Technical Service Bulletin: TSB110002

Released Date: 21-Feb-2011

Possible Water Pump/Cylinder Block Interference on ISM and QSM11 Engine Applications

Water Pump Housing and Cylinder Block Casting

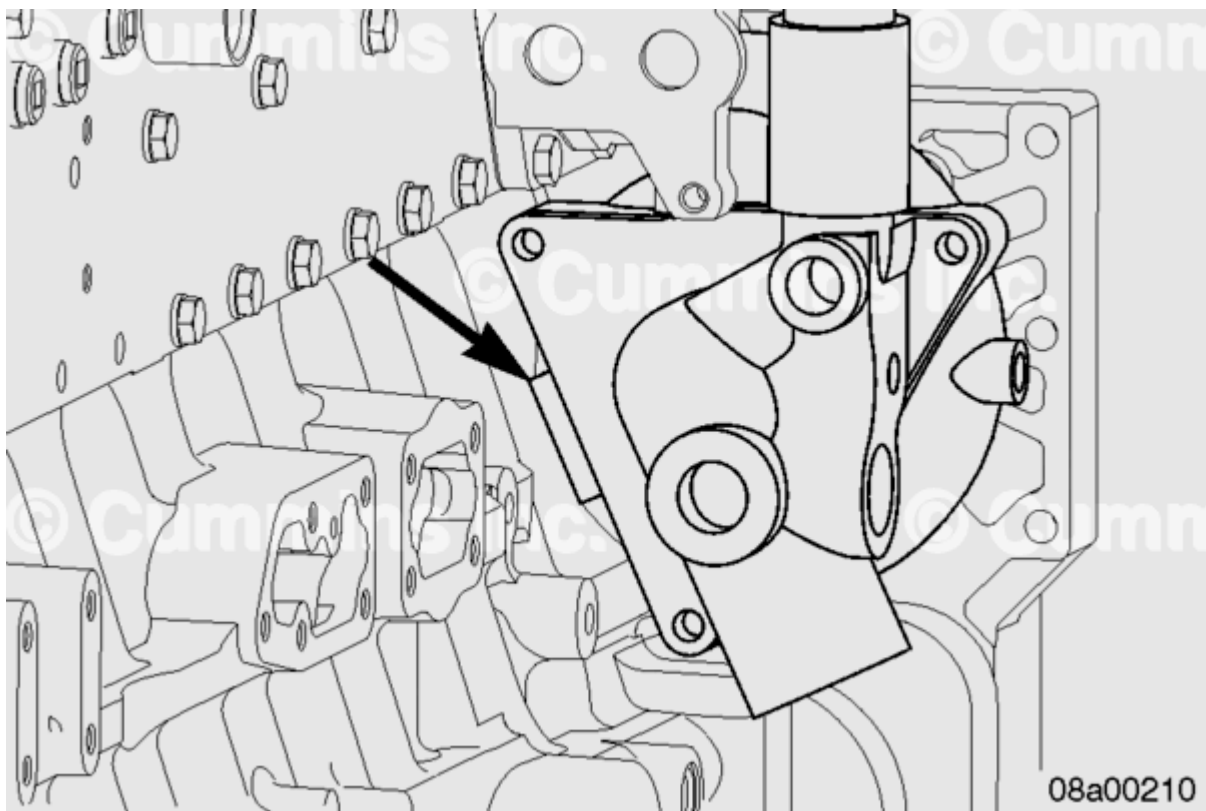
This document describes a condition in which there may be interference between the water pump housing and the cylinder block on some ISM and QSM11 engines. Due to the manufacturing and process variation between components, it is possible for the water pump housing to contact the cylinder block casting, behind the cylinder block to gear housing interface. This issue may result in an external coolant leak from the water pump housing or an issue with the water pump bearing. If the engine is experiencing an external coolant leak from the water pump housing or an issue with the water pump bearing, the engine **must** be inspected for this possible interference condition before the water pump is removed for repair.

Inspect for interference between the water pump housing and the cylinder block casting by sliding thin cardboard or cardstock between the components. See illustration below.

If interference is found, it may be necessary to remove the water pump from the engine to correct the interference by grinding a small amount of material from the affected area of the cylinder block casting or water pump housing. Use the following procedure in the ISM, ISMe, and QSM11 Service Manual, Bulletin 3666322. Refer to Procedure 008-062 in Section 8.

Note : Care must be taken to properly cover any exposed engine components during the grinding process and to seal or paint the area exposed by grinding.
